PROJECT NO. 35077

THIRD AMENDMENT TO THE ERCOT
STANDARD GENERATION INTERCONNECTION AGREEMENT
BETWEEN CROSS TEXAS TRANSMISSION, LLC
AND SALT FORK WIND, LLC

**THIRD AMENDMENT TO THE
ERCOT STANDARD GENERATION INTERCONNECTION AGREEMENT**

EXHIBIT "C-1"
CONCEPTUAL ONE-LINE OF INTERCONNECTION FACILITIES

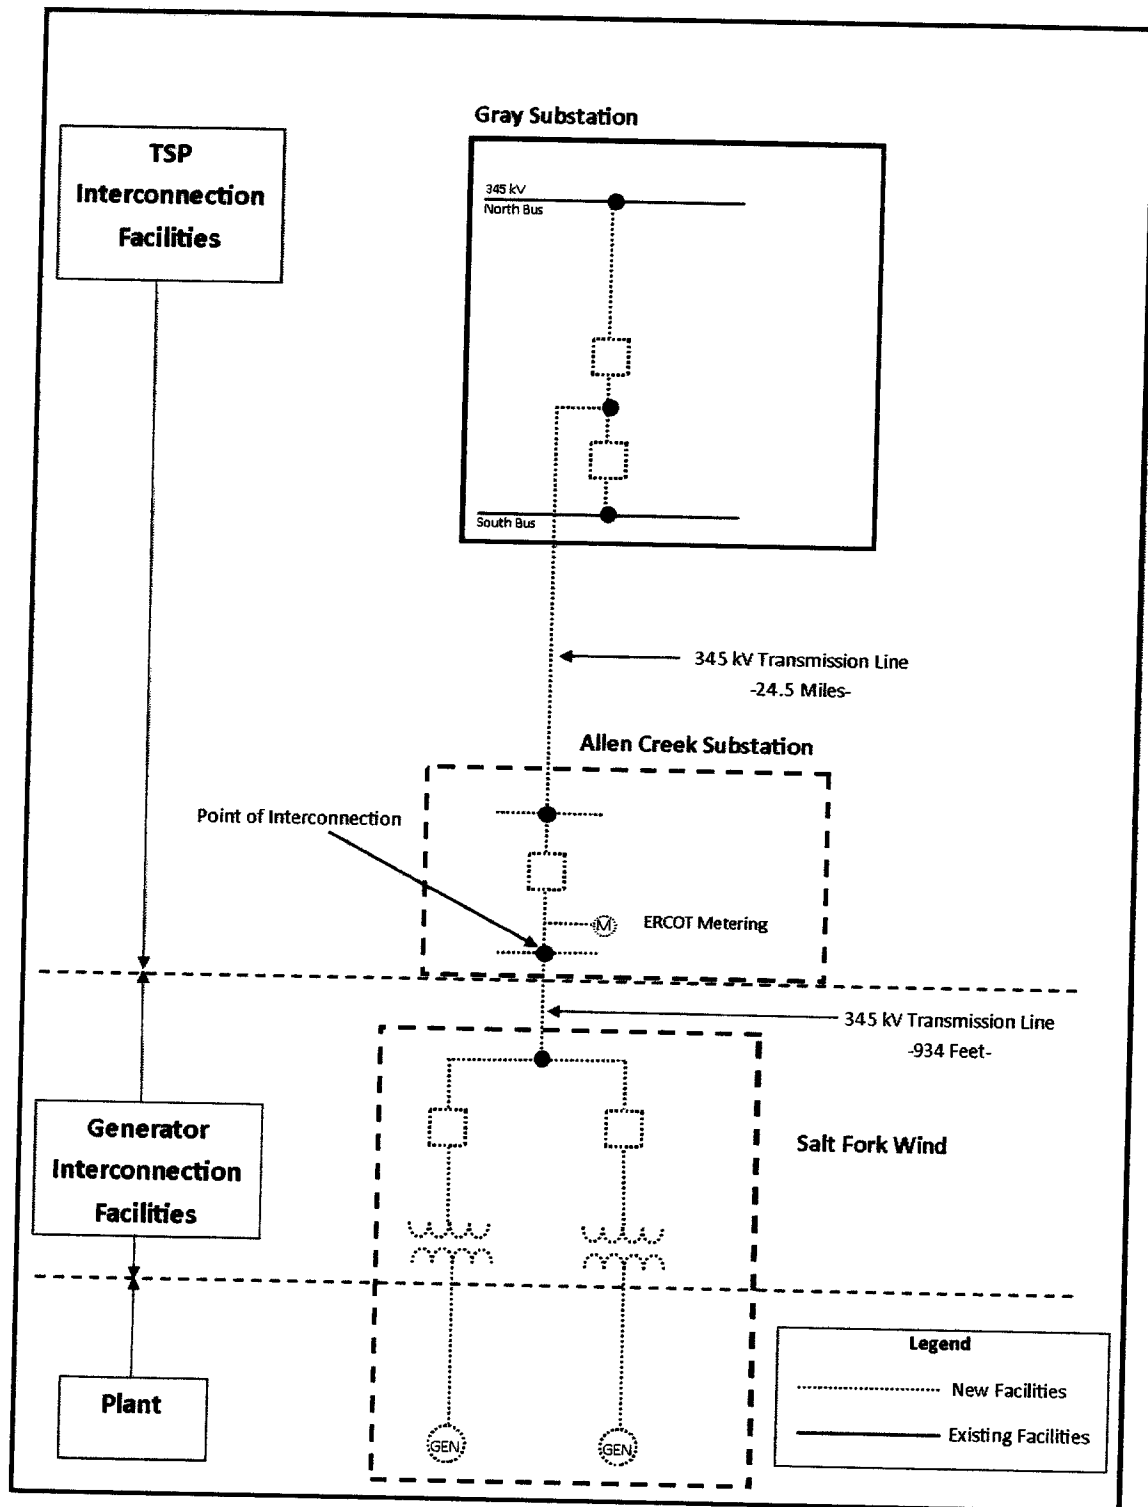
3. Exhibit "C-1" of the Agreement is hereby deleted and replaced in its entirety with the Exhibit "C-1" attached to this Third Amendment.
4. Exhibit "D" of the Agreement is hereby deleted and replaced in its entirety with the Exhibit "D" attached to this Third Amendment.

- 1) Name: Salt Fork Wind, LLC ("Salt Fork Wind")
- 2) Point of Interconnection location: The Point of Interconnection is located in the northern part of Donley County, Texas within the TSP's new Allen Creek substation ("TSP substation"). The Point of Interconnection shall be defined as the point where the Generator's 345 kV transmission line, originating from the Generator's substation, terminates the phase conductors and associated equipment on the TSP's dead-end structure located inside the TSP substation. Exhibit "C-1" shows the location of the Point of Interconnection on the one-line.

- 6) Metering and Telemetry Equipment:
 - a) ERCOT Polled Settlement ("EPS") metering will be located at the TSP substation. The metering equipment described below will be procured, owned and installed by the TSP inside the TSP substation. See Exhibit "C-1" for the location of the ERCOT EPS metering on the one-line.
